Bristol Tree Forum response to the Small Sites Metric consultation

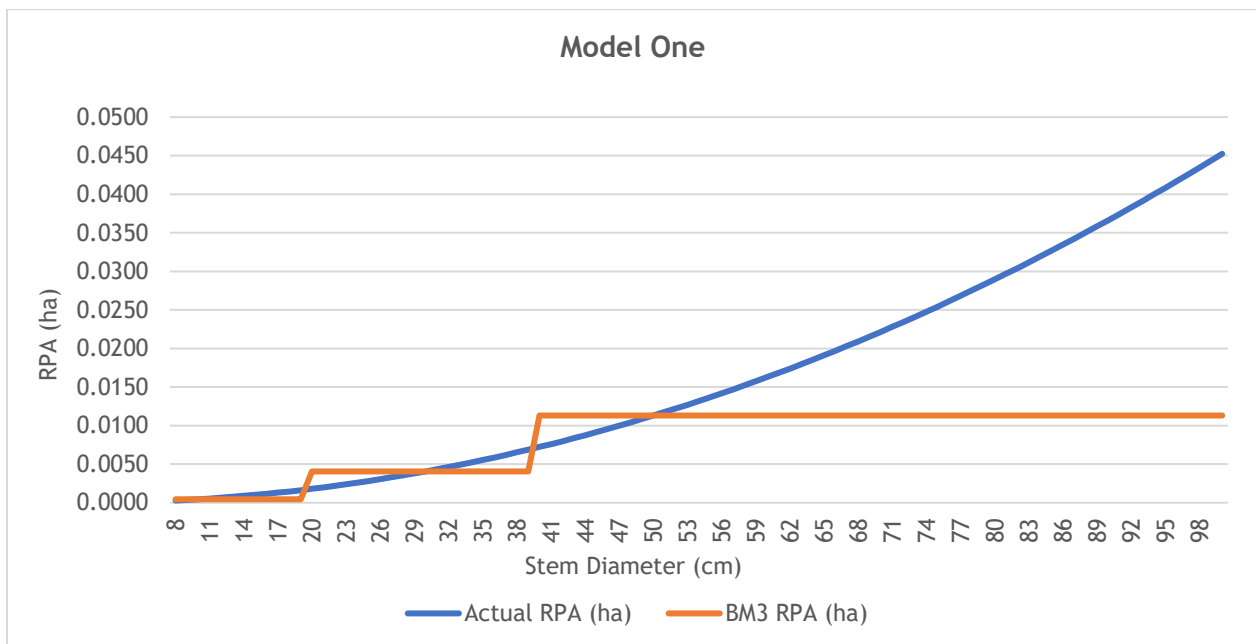
In the course of our discussions, the applicant's ecologist explained that he and his colleagues apply the table by assigning urban trees as follows: DBH less than 30 cm = Small, DBH between 30cm and 50cm = Medium, and DBH >=50cm = Large.

We pointed out that the effect of this is significantly to undervalue the habitat area of urban trees - all trees with a DBH greater than 10, 30 or 50 cm will have their habitat areas undervalued.

We said that, on its face, the table is unworkable, but by way of compromise (and because we must find a way to use it while it applies) it would be better to set the ranges to Small = DBH <20cm. Medium = DBH >= 20 cm and <40 cm and Large = DBH >=40 cm. This is still not ideal but at least it undervalues fewer urban tree habitats.

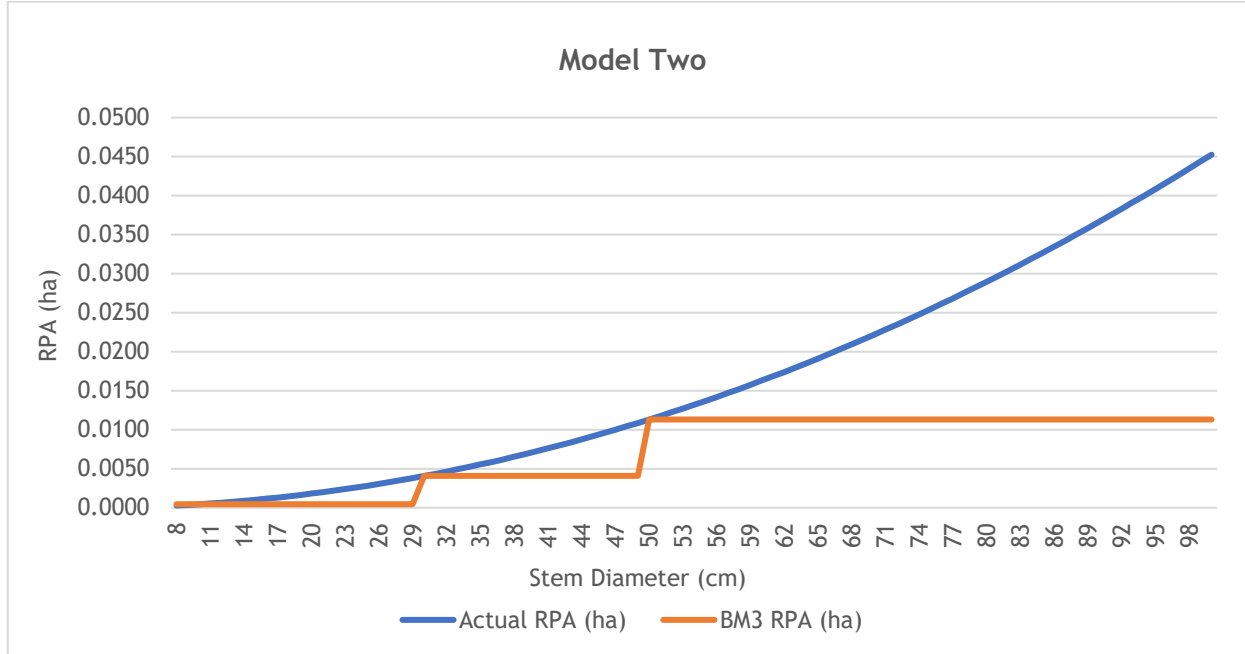
To illustrate our point, we have calculated the Root Protection Areas (RPA) for trees with stem diameters from 8 cm to 100 cm.¹ We have then modelled the two scenarios set out in the email above - Model One where the step changes from Small to Medium then Medium to Large occur at 20 cm and 40 cm and, Model Two, where they occur at 30 cm and 50 cm. These are the results shown as graphs:

In both cases, the majority (all bar three in the case of Model Two) of habitat areas are discounted as a result of the Urban Tree area size constraints imposed by the Metric such that, by the time the area habitat of a tree with a DBH of 71 cm is measured, it has been discounted by 50%. If the tree’s DBH is 100 cm, then the discount is 75%. Trees like this are often veterans which offer a very rich biodiversity value.

Why should this be so? No other area habitat has had sort of discount imposed.

In our view, it would be far better if the actual, measured RPA of a tree was used, or better still, the tree’s canopy area (also reported in a BS 5837-compliant Arboricultural Impact Assessment). Tree canopy is a far better proxy for the habitat that an tree provides than using its RPA.
